Well Name: MULE 11-14 FED COM

Well Number: 526H

Sundry ID: 2791627

Type of Action: APD Change

WELL LOCATION AND ACREAGE DEDICATION PLAT

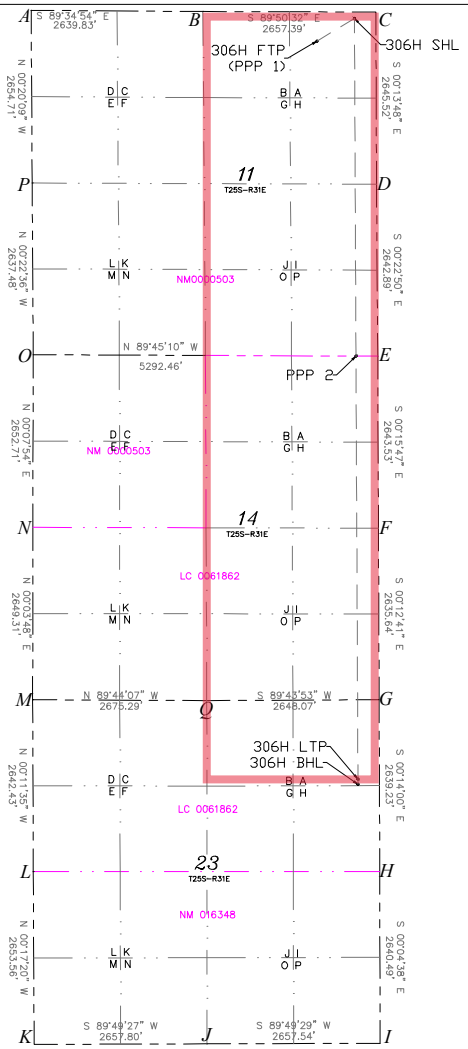
Permitted Well name: MULE 11-14 FED COM 526H
Proposed Well name: MULE 11-23 FED COM 306H
Permitted BHL: SESE, 20 FSL, 330 FEL, 14-25S-31E
Proposed BHL: NENE, 1298 FNL, 330 FEL, 14-25S-31E
Permitted TVD/MD: 8935/19160
Proposed TVD/MD: 10475/22135

UL or lot No.	Section	Township	Range	Lot Idn	Feet from the	North/South line	Feet from the	East/West line	County
A	23	25-S	31-E		1298	NORTH	330	EAST	EDDY
